1. Building Heights: Comments on Maximum Heights for R1 and R2 zones
2. Neighbourhood *Interior* Zoning: Applicability of N3C
3. Inconsistently zoned lots on Patricia Avenue and Sunnymede Avenue.

#### City of Ottawa: Revised - Document 3 - Overview of Key Issues and Options

- Example: please see *Appendix 1 site&floor plans* for a 2 ½ storey semi-detached development in Champlain Park (submitted to the CofA: D-08-02-21/A-00129 & 130; D08-01-21/B-00116).

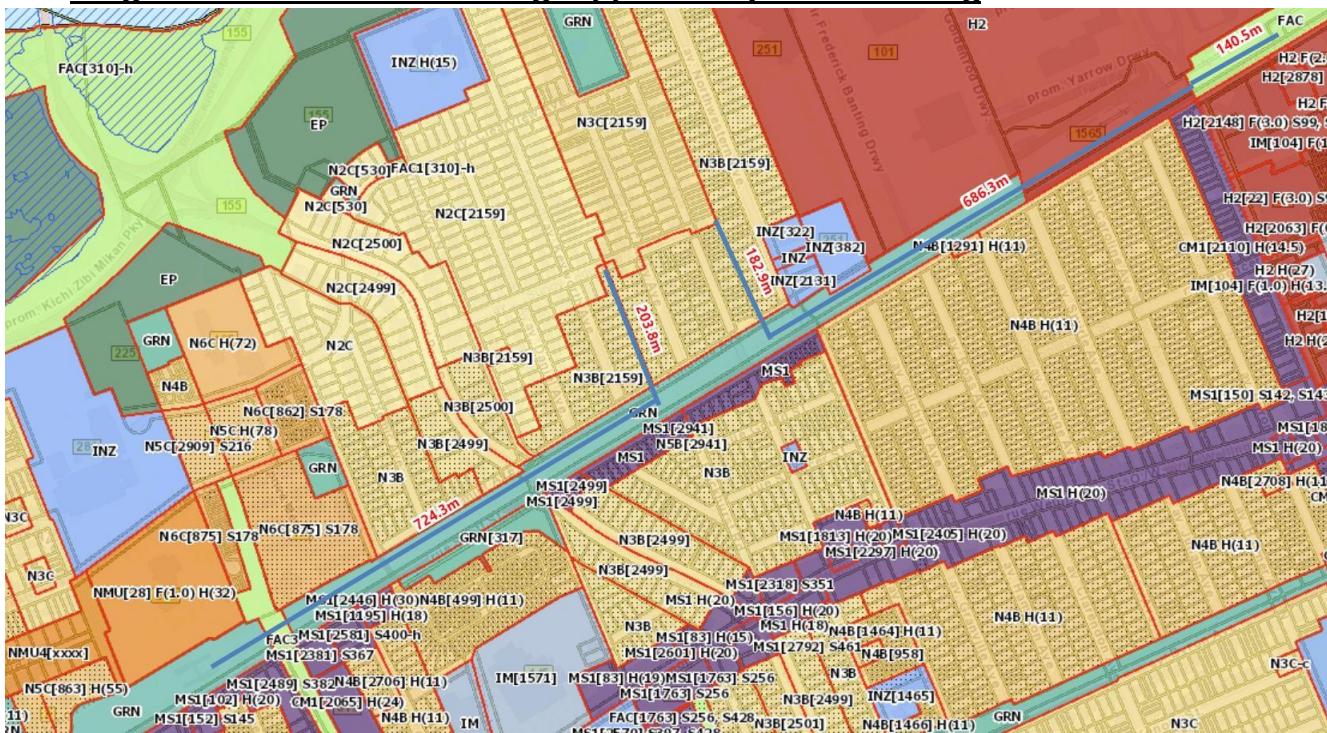
- As noted on page 2, the OP generally permits 3 storeys and four where appropriate.
- An 8 ½ metre height requirement, on a 50 X 100 foot lot, with 6 metre front yard setback and 28 % rear yard setback, allows developers a 2 ½ storey, semi-detached building plus basement that can accommodate up to 8 apartments with ease. The building could accommodate 2 bed, one bed and bachelor apartments.

- Space is freed-up on the first floor for other uses when car storage is no longer required.
- Champlain Park has several examples of 2 ½ storey, 8 ½ metre to the midline of the roof, semi-detached buildings with garages. **The building envelope can easily support the number of units noted above.**

- Land size 25 X 100 feet
- Listed square footage is 3000-3500 square feet
- 5 bedrooms; 5 bathrooms
- Self-contained Secondary Dwelling Unit.
- **Met height and setback requirements for Mature Neighbourhoods Overlay and Alternative Provisions**

**Staff Response:** Staff are recommending a general height of 11 metres in the final draft, except where existing height suffixes or Secondary Plan policies dictate a lower building height must be permitted instead.

Staff note that this implements the transect policies in the Official Plan which within the Neighbourhoods designation generally contemplate a height of three storeys, and further allows for greater flexibility for large units within multi-unit dwellings, which can assist in achieving the large-household unit targets set out as part of Section 3 of the Official Plan. Staff do not agree that such a move would "negate" the Official Plan's intent when three-storey heights are contemplated in a range of locations including within the Inner Urban transect and where other designations, such as Mainstreets and Hubs, do concentrate a significantly greater degree of building height up to and including high-rise buildings. Staff further note that the height permissions of three storeys is not universal, and existing height suffixes that prescribe lower height limits would be retained, including those tied to Secondary Plans or more area-specific policies.

Staff would further note that this proposed increase of building height to 11 metres represents an increase in the allowable height and does not represent a "requirement" for buildings to be three storeys. A property owner can still choose to build only to a two-storey height if they so desire.

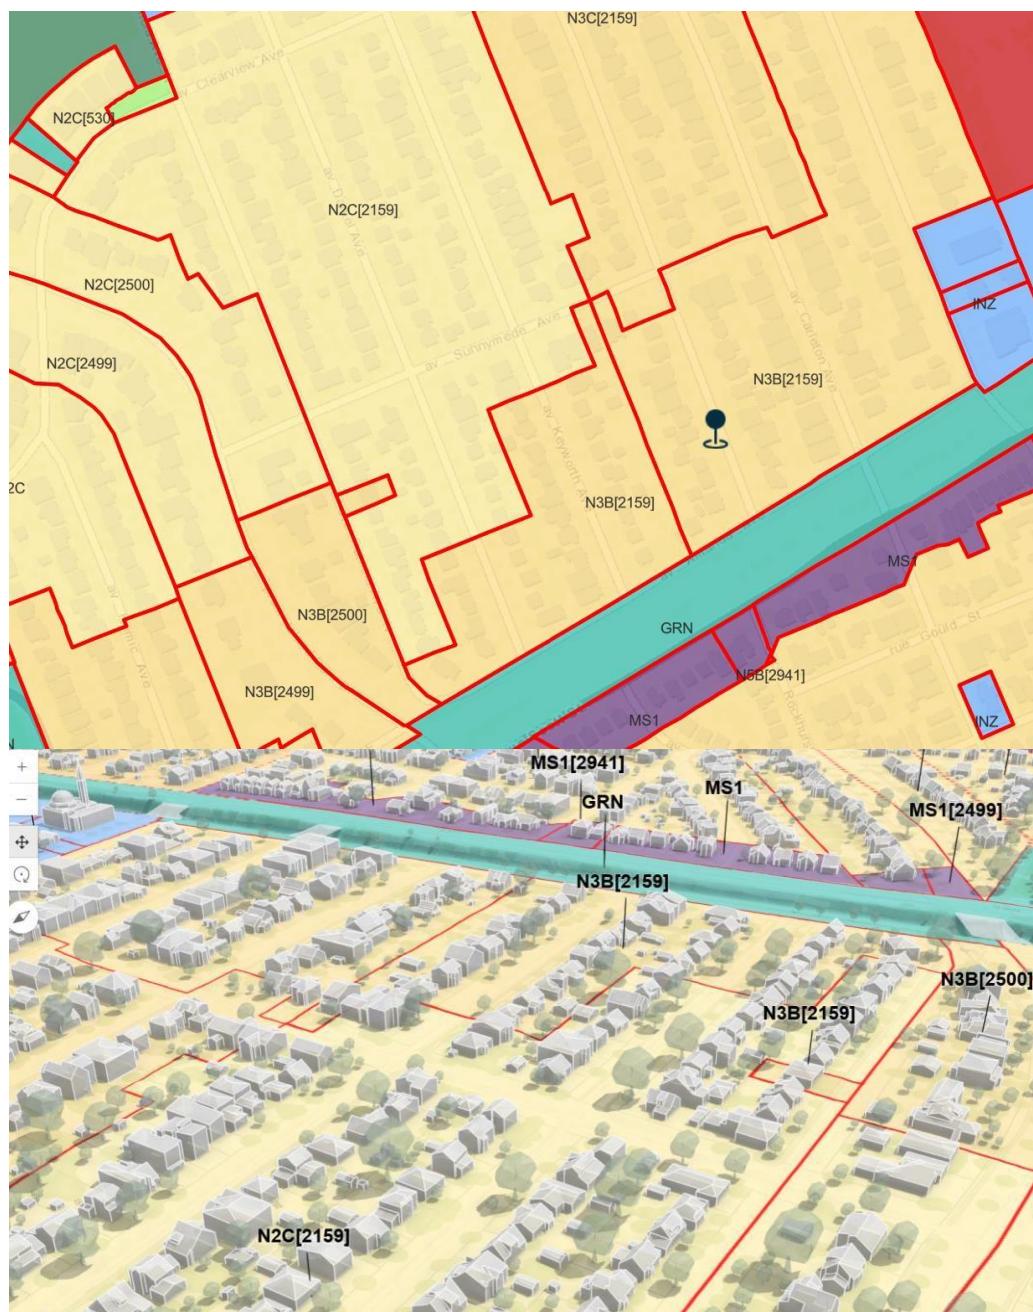
#### 3.1 Why is 241 Patricia Avenue in the south block of Patricia Ave. singled out for higher density zoning, at N3B (2159), than all of the surrounding lots?

The three lots to its north are zoned N2C (2159). The seven lots to its south are zoned N2C (2159).

The seven lots to its east on Daniel Ave. are N2C (2159).

Yet, 241 Patricia Ave., in the Interior of the neighbourhood, and not in the ENO, is shown having the same zoning as the block's most southerly lot, closest to the LRT line N3B (2159).

3.2 Why does the boundary along Sunnymeade Avenue, jog along the north side of the street between Keyworth and Carleton Avenues? Zig-zag zoning on this section of Sunnymeade between Keyworth and Carleton Avenues seems needlessly complicated.

Interior N3C(2159)

Interior N2C(2159)

56 Sunnynede=N3C / 60 Sunnynede=is N3B / 64 Sunnynede=is N3B / 68 Sunnynede=is N2C / 231 Keyword=N2C

**Staff Response:** The proposed zoning of these property appears to be an error that will be addressed in the final mapping.
